Addendum #

Bid Opportunity: 26-7845-RFT - Courtland Avenue Public School Paving and Site Renovations

Closing Date: Tuesday, February 24, 2026 2:00 PM

1 SITE PLAN TYPICAL 1:300
SPA.01

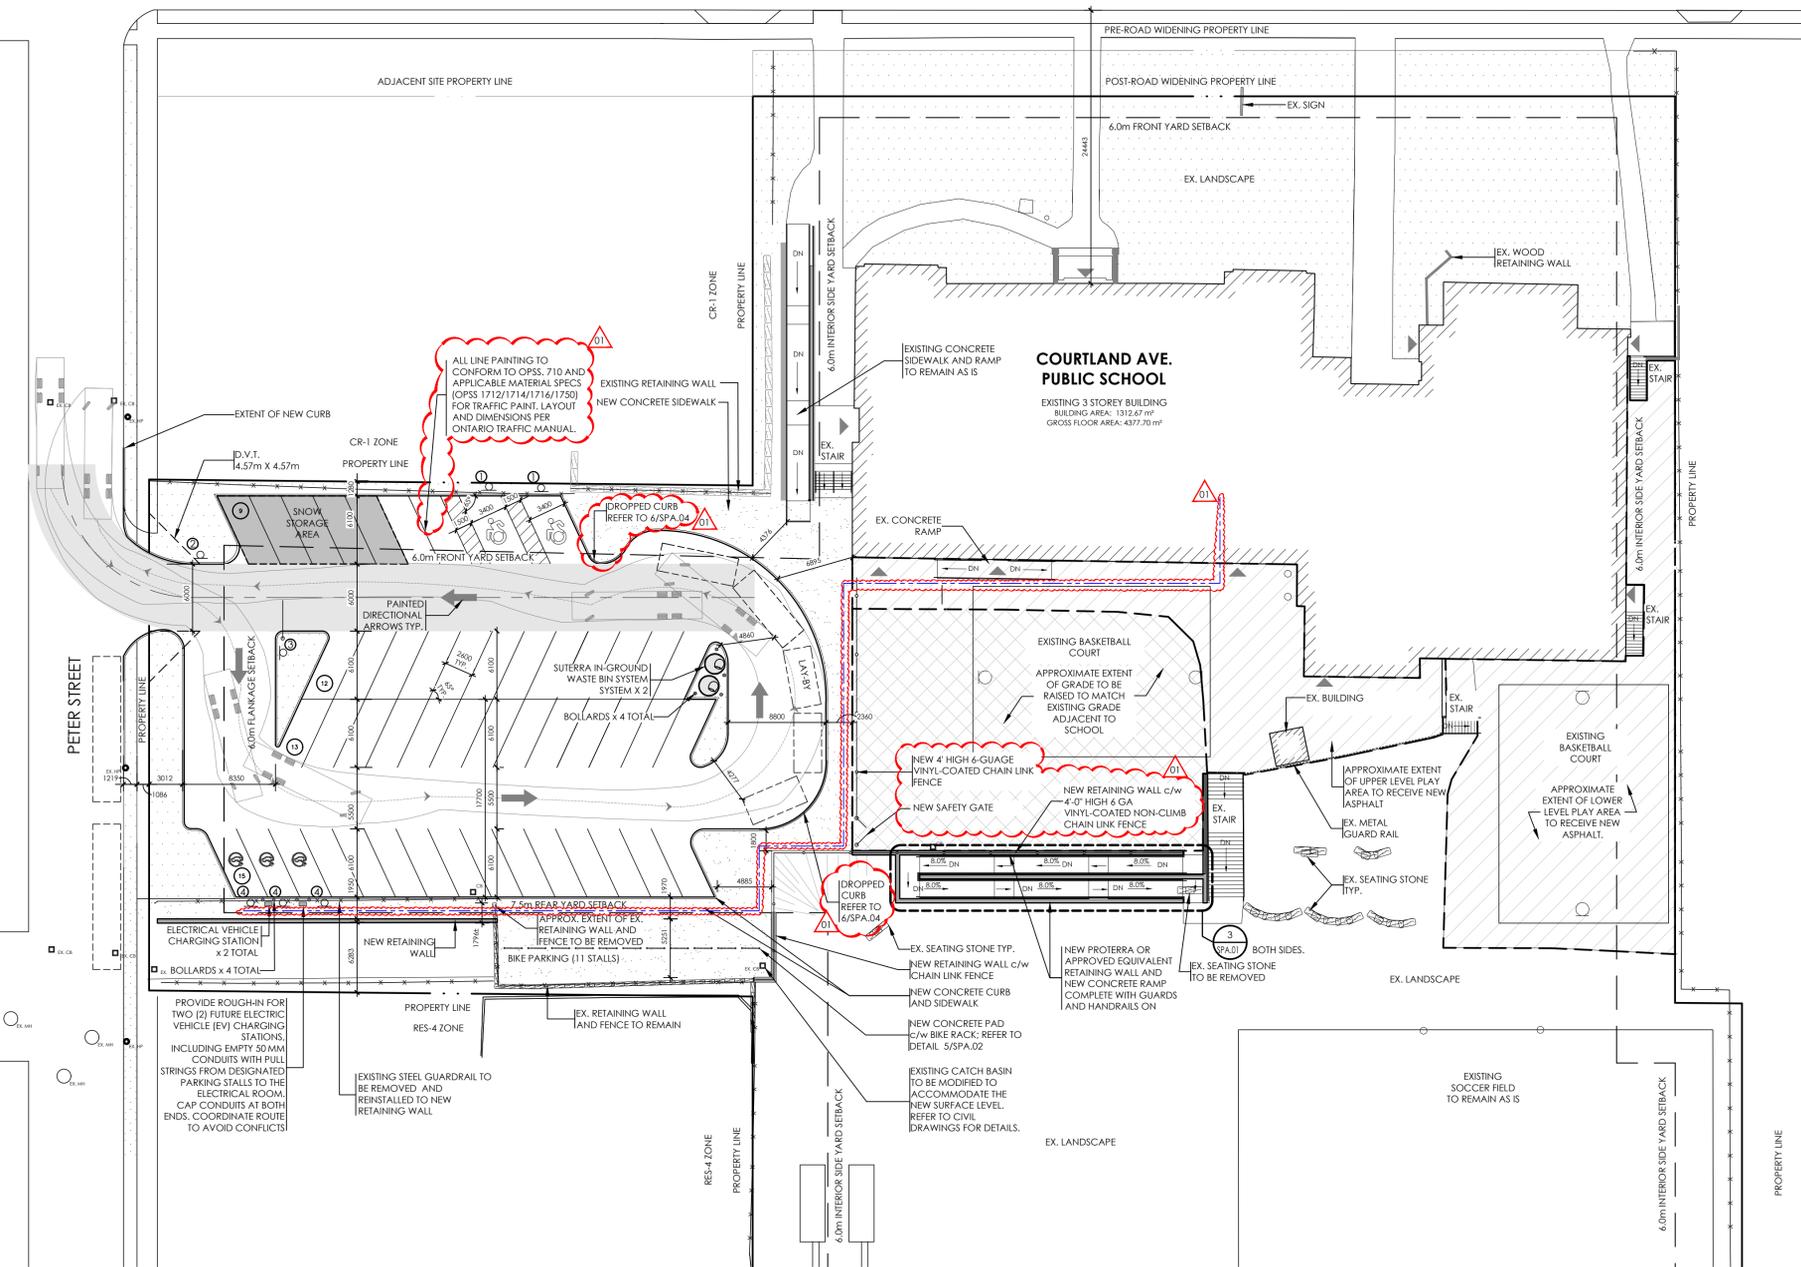
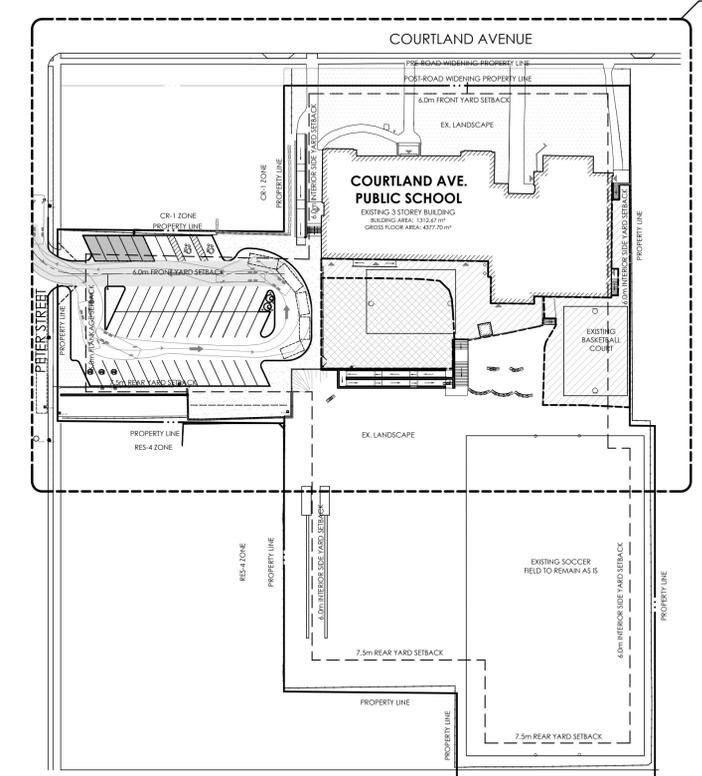
Provide site electrical drawings showing underground conduit pathway and connection point to electrical room for new EV chargers.

Can you please confirm the height of the fence required. SPA.01 calls for 4'-0" however detail 1/SPA.02 calls for 6'-0" (H).

On SPA.01 there is a note to provide empty buried conduits for EV charging stations. Please identify the location of the electrical room and termination details at each end of the conduit.

Please show where drop curbs and tactile plates detailed on SPA.04 are to be installed.

Please provide a specification for line painting.

Revised Architectural Drawings (clouded) are attached showing the intended exterior conduit pathway from the EV charging area to the building. The conduit runs around the building and enters at the Boiler Room, which is the designated connection point for continuation to the main Electrical Room.

The routing shown is diagrammatic and provided for design-intent only; the final route shall be field-verified and coordinated during construction.

- Exterior underground conduit: ~140 m
- Interior conduit: ~10–20 m, depending on field routing between the Boiler Room and Electrical Room

4'-0" to be carried – Refer to the attached Addendum 01 Architectural Drawings (as clouded) SPA.01 and SPA.04 dated February 13, 2026.

Refer to the attached Addendum 01 Architectural Drawings (as clouded) SPA.01 dated February 13, 2026.

Refer to the attached Addendum 01 Architectural Drawings (as clouded) SPA.01 dated February 13, 2026.

5 DROPPED CURB - SECTION AT CONCRETE SURFACE TYPICAL DETAIL
 SPA.04 1:10

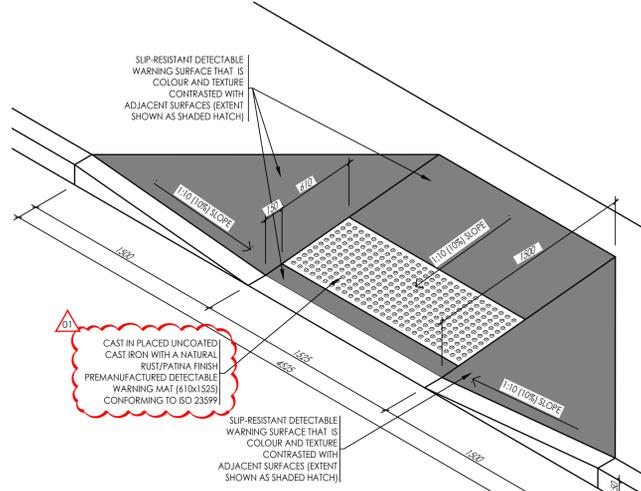
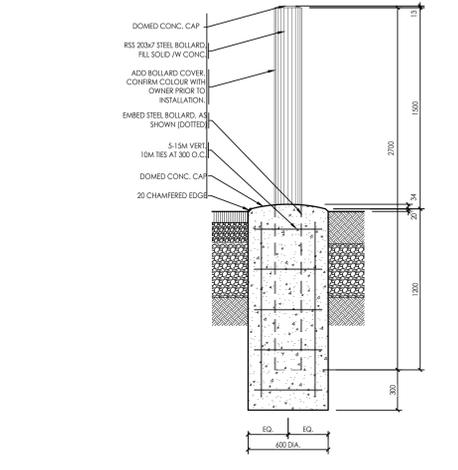
Please provide a specification for the tactile plates, are they fiberglass, cast iron or stainless steel. Surface applied or cast in place?

Refer to the attached Addendum 01 Architectural Drawings (as clouded) SPA.04 dated February 13, 2026.

12 RAMP GUARD DETAIL AT LANDING TYPICAL DETAIL
 SPA.04 1:10

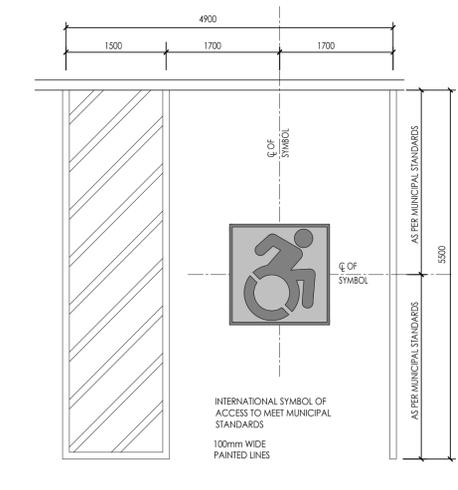
The handrail detail 12 on SPA.04 calls for galvanized rails and balusters with painted pickets; is this correct?

All balustrade and handrail components shall be hot-dip galvanized and finished with a powder-coat colour. This applies to rails, balusters, and pickets.

DESIGNER	JHV	PROJECT NO.	11281-301
DRAWN	JHV	DRAWING NO.	C2.0
DATE	FEBRUARY 2026		
SCALE	1:200

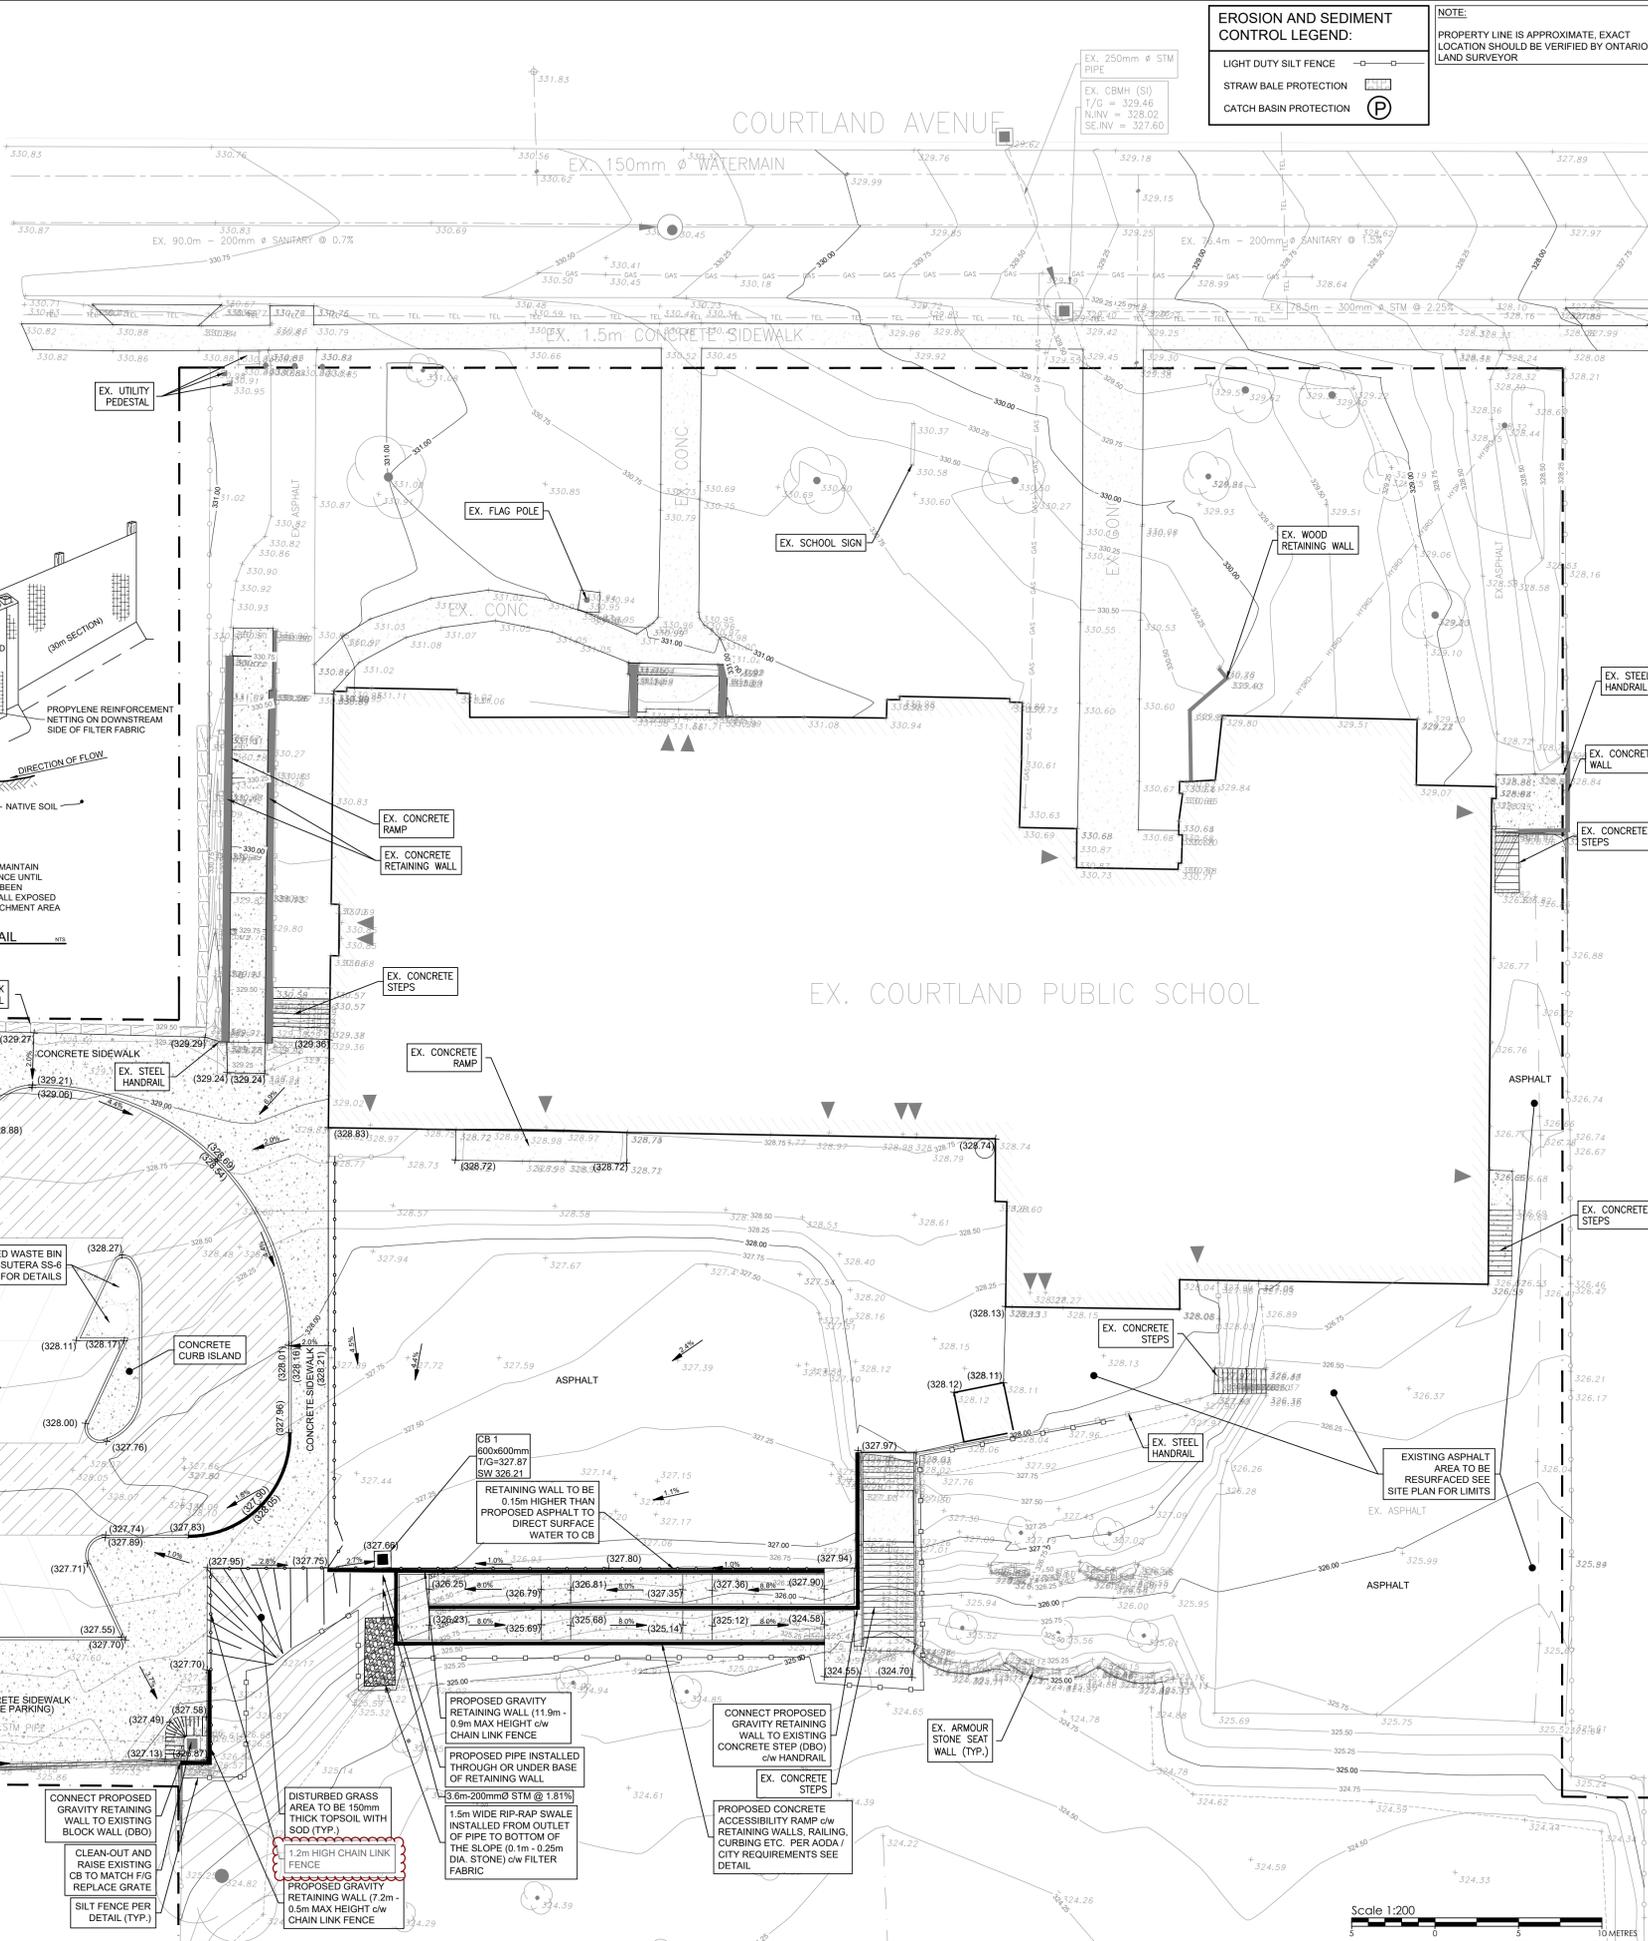
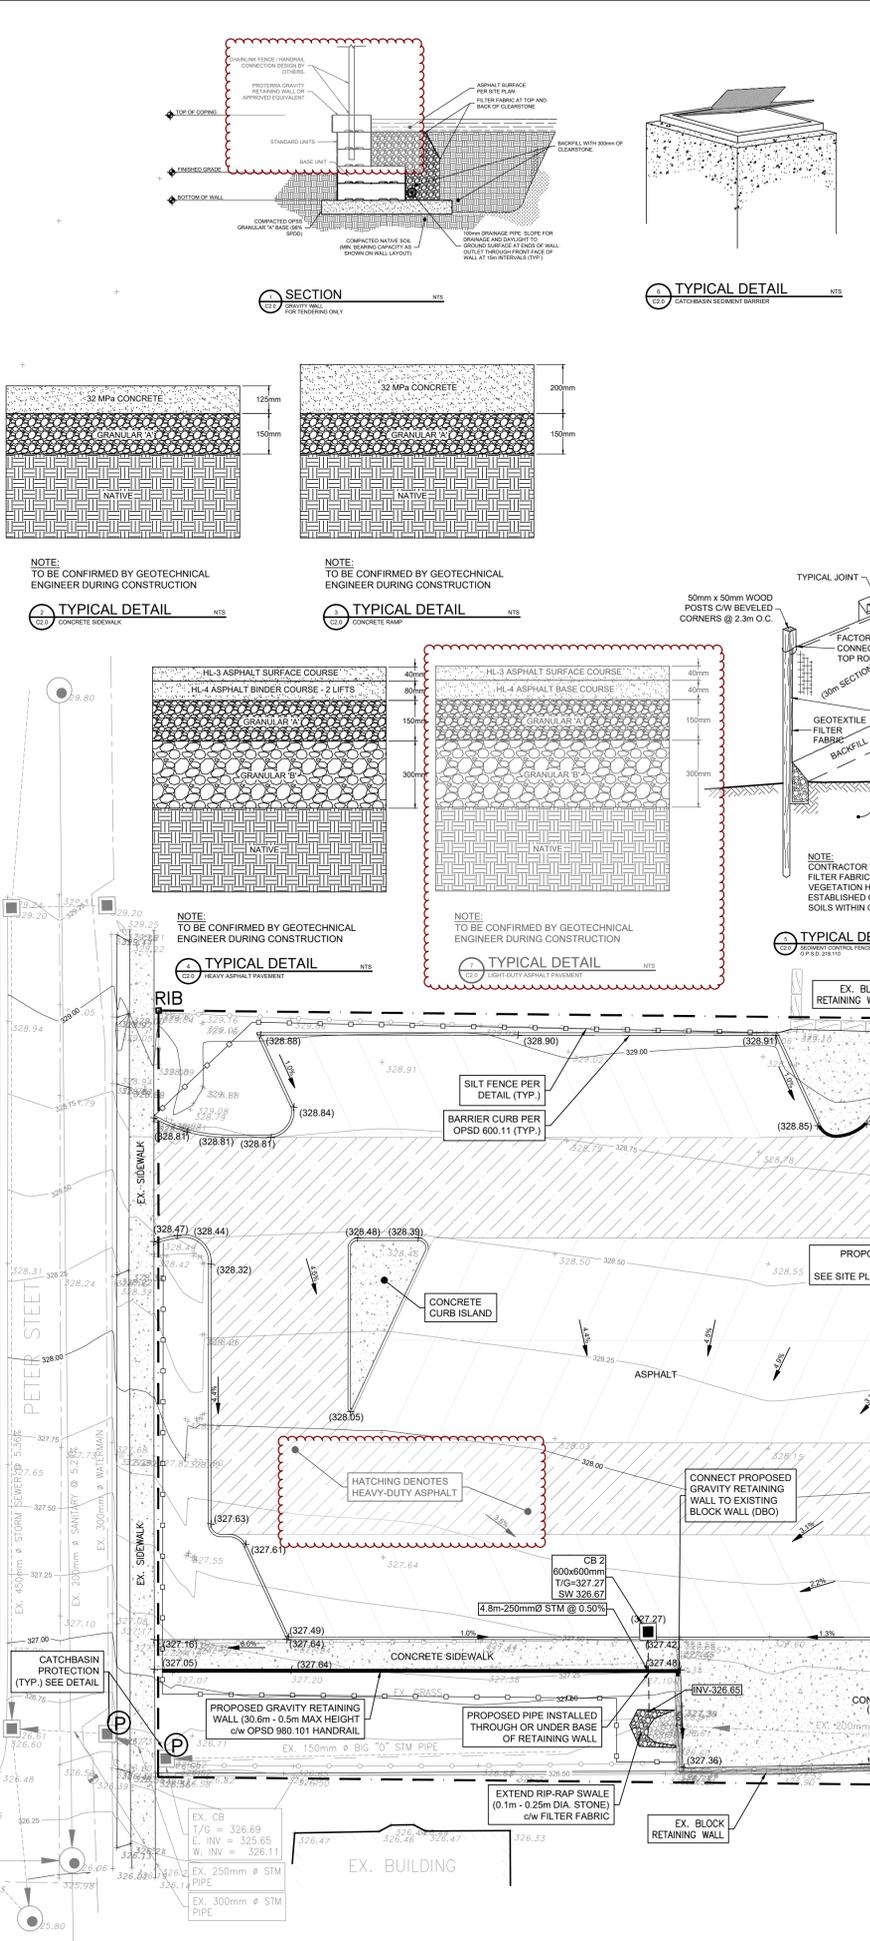
On drawing c2.0 it's noted that the asphalt play areas are to be 'resurfaced'. Do the asphalt play areas require excavation of existing granular base and new Granular A / B placed or is it just removal of asphalt and touch up the existing granular base with A gravel as required?

-Drawing C2.0 details 150mm of Granular A & 300mm Granular for asphalt but SPA.04 details 250mm Granular A under asphalt and states to refer to specifications for Granular B, specifications section 00 01 00 details for us to refer to drawings for granular specifications. I just need to know if I should follow civil drawings or site plan and if so, please provide granular B depth.

Will heavy duty paving be required for the parking lot and / or the bus loop?

No, this scope should include removing and disposing of existing asphalt, fine grading of underlying granulars, and repaving.

Granular and Asphalt thickness should follow Civil Plans and be verified by Geotechnical Engineer.

Yes, Heavy Duty Asphalt is proposed for the parking and bus turning area and, light duty for the play area - Refer to the attached Addendum 01 Civil Drawings (as clouded) C2.0 prepared by Witzel Dyce Engineering Inc. dated February 13, 2026.
